Product/Process Change Notice (PCN)

PCN #: WE_CMBHC_20140422

Product Affected: WE-CMBHC

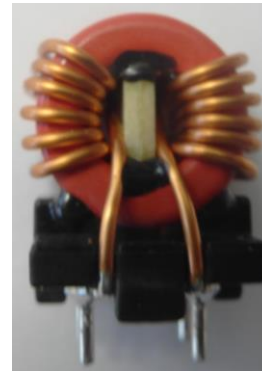
In order to increase product reliability, the spacer has been changed.
The effective date code is July 22nd, 2014. Shipments with both product revisions are possible.

1. Due to continuous improvements, we invested in a new spacer tooling to improve our production quality. The new spacer doesn't need to be glued. The plastic raw material has been changed from FR4 to Ultramid A3X2G5. This change will not affect any other specified parameters of the components.
2. The packaging unit will be changed from 80 pieces to 90 pieces.
